Shutters and Secondary Glazing Specification

ML1-LOOM-RIBA4-FCB-DA-00-00-A-1777-A-03406-A

MANCHESTER LIFE PLOT 3
LOOM
SECONDARY GLAZING DETAILS
DECKER MILL

00 PLAN (1:5 at A1)

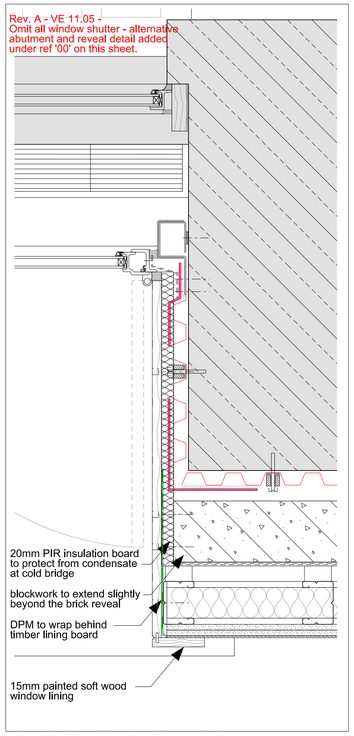
Amendment	Date
Rev	
A - 08.01.16 VE - 1.06, 1.07, 2.01 and 2.02 - Brass angle bead omitted and galv / powder coated bead added back. VE - 1.05, 1.08 and 1.09 - Oak cill board omitted - painted softwood added back. Thickness of linings and soffit to be reduced. VE - 11.05 - Shutters to be omitted. Detail 00 - Jamb detail added to show updated arangement of assembly without shutters and shutter frame managing the junction.
